# ADA Curb Ramp New Construction Inspection Form (Parallel)

NW 309th Ave

24952.54

NW Brooking Ct

PARALLEL RAMP (PL)

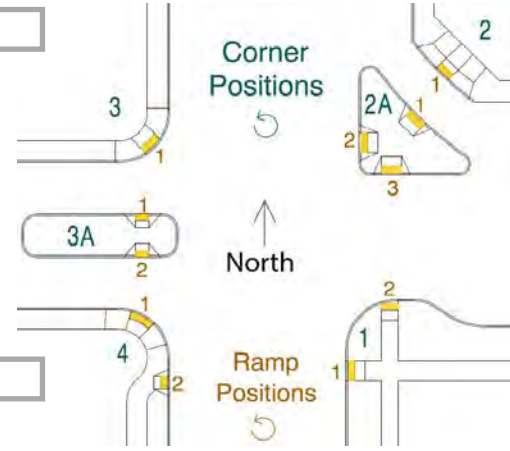
$\leq 2.0\%$  ☐  $> 2.0\%$  ☒

4.1  $\leq 2.0\%$  ☐  $> 2.0\%$  ☒

N Y ☐ N ☒

1.0  $\leq 1/4"$  ☐  $> 1/4"$  ☒

☐ 9.78  $\leq 8.3\%$  ☐  $> 8.3\%$  ☒

N Y ☐ N ☒

$\leq 8.3\%$  ☐  $> 8.3\%$  ☒

4.2  $\leq 2.0\%$  ☐  $> 2.0\%$  ☒

$\leq 8.3\%$  ☐  $> 8.3\%$  ☒

4.3  $\leq 2.0\%$  ☐  $> 2.0\%$  ☒

3.85  $\geq 4.0'$  ☐  $< 4.0'$  ☒

4.1  $\leq 2.0\%$  ☐  $> 2.0\%$  ☒

$\leq 2.0\%$  ☐  $> 2.0\%$  ☒
